STATE OF CONNECTICUT  
CONNECTICUT SITING COUNCIL

APPLICATION OF NEW CINGULAR  
WIRELESS PCS, LLC (AT&T) FOR A  
CERTIFICATE OF ENVIRONMENTAL  
COMPATIBILITY AND PUBLIC NEED FOR  
THE CONSTRUCTION, MAINTENANCE  
AND OPERATION OF A  
TELECOMMUNICATIONS TOWER  
FACILITY AT 28 GREAT OAK LANE  
IN THE TOWN OF  
REDDING, CONNECTICUT

DOCKET NO. 404

NEW CINGULAR WIRELESS PCS, LLC ("AT&T")  
RESPONSES TO SITING COUNCIL INTERROGATORIES (SET ONE)

## **EXHIBIT A**

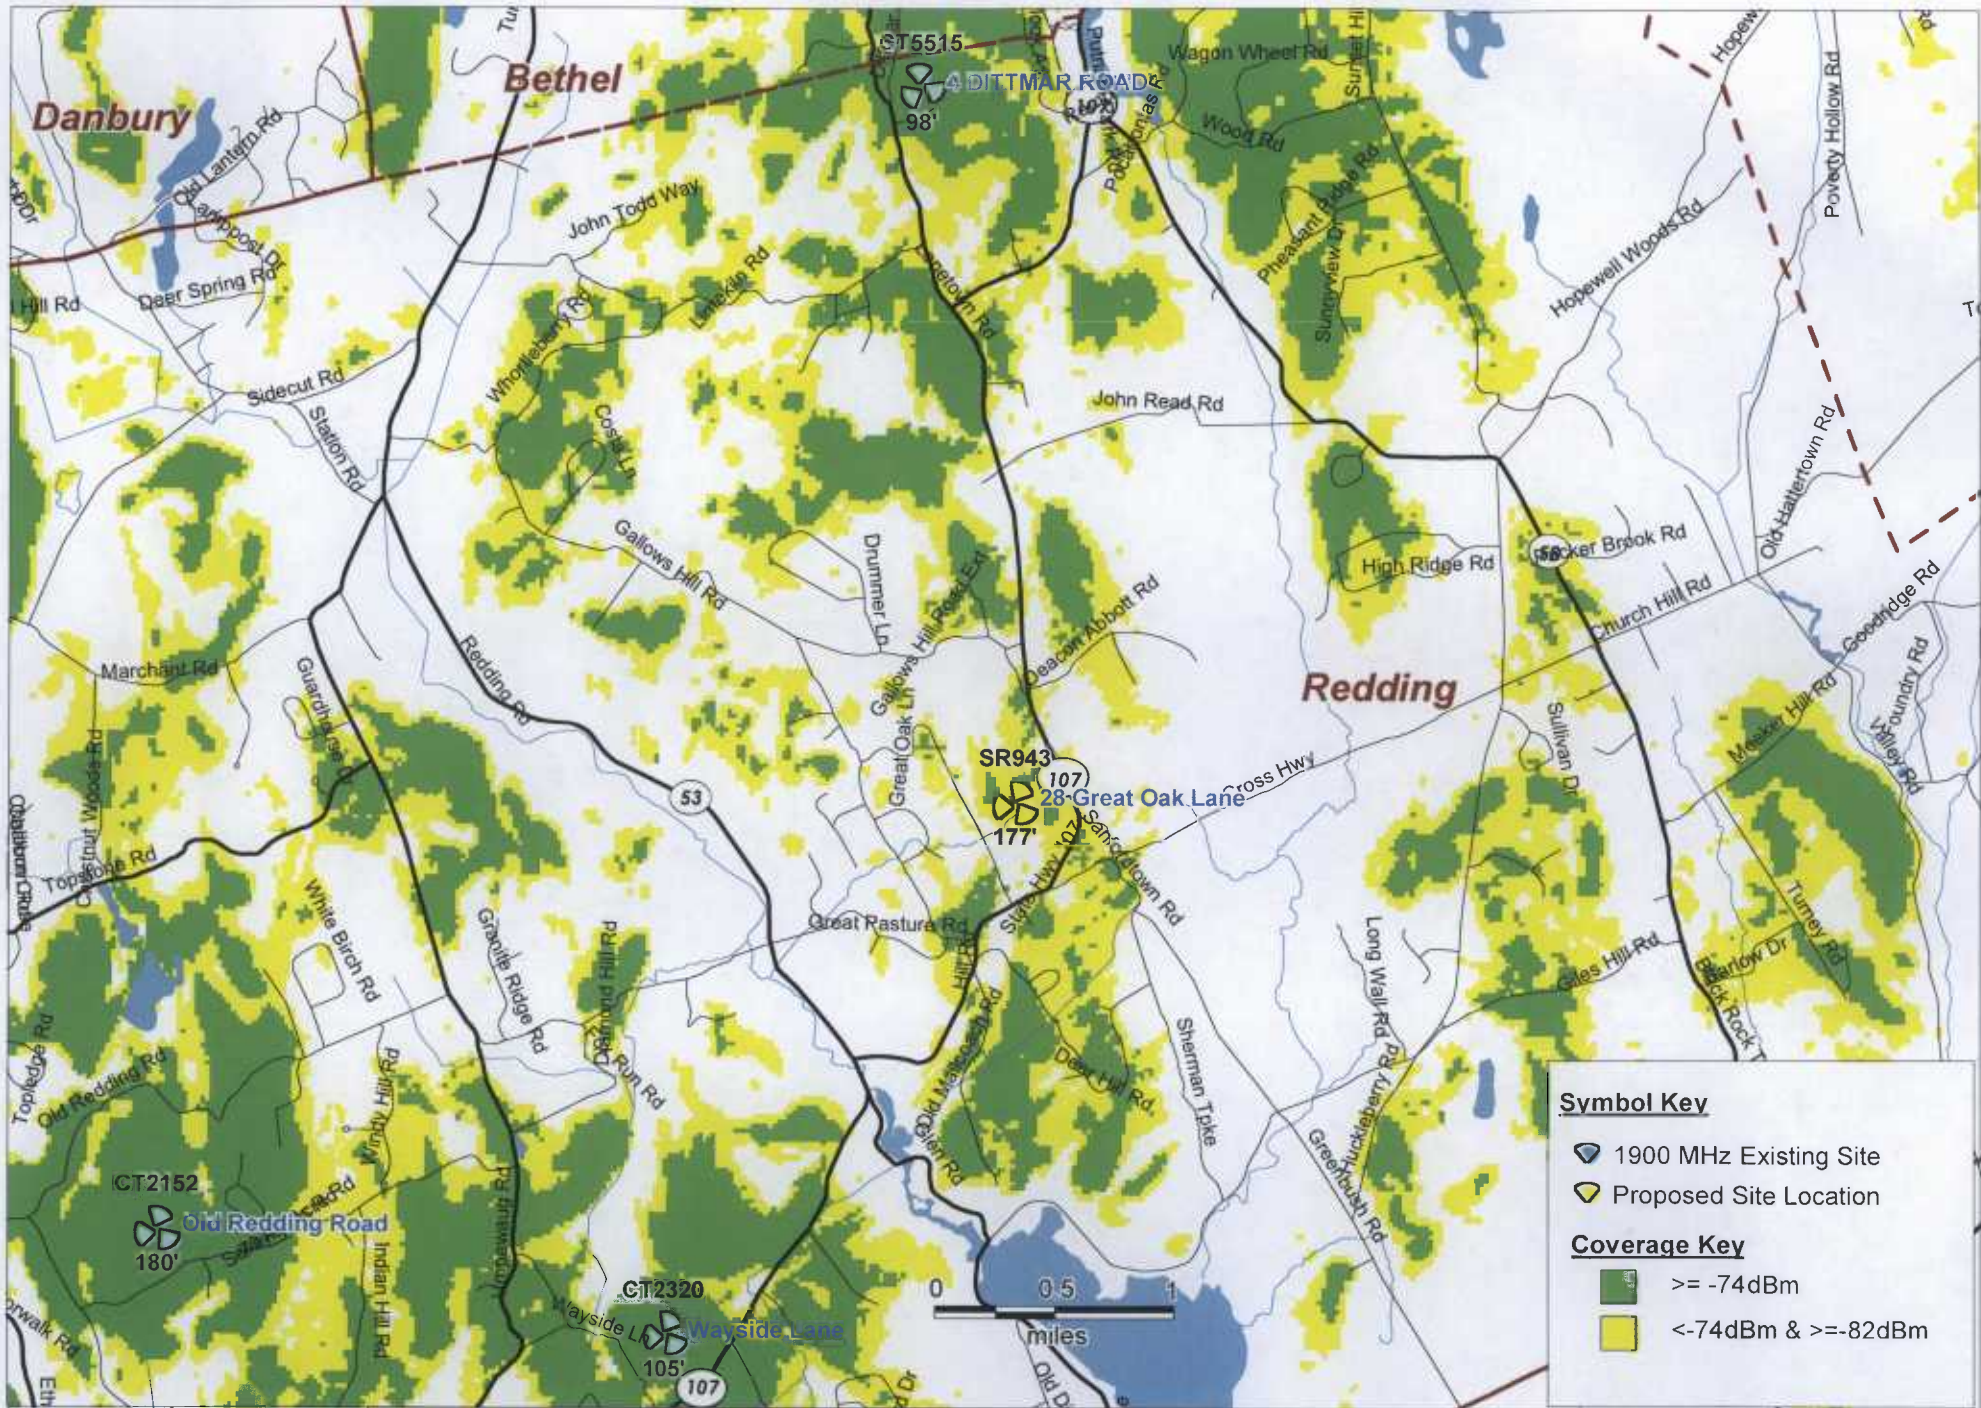
Q3. Provide PCS coverage plots, using the scale and thresholds in Application Attachment 1 that depicts the following:

- a) coverage from existing/approved AT&T sites; and
- b) coverage from existing/approved AT&T sites and the proposed sites.

A3. PCS plots are attached as Exhibit A.
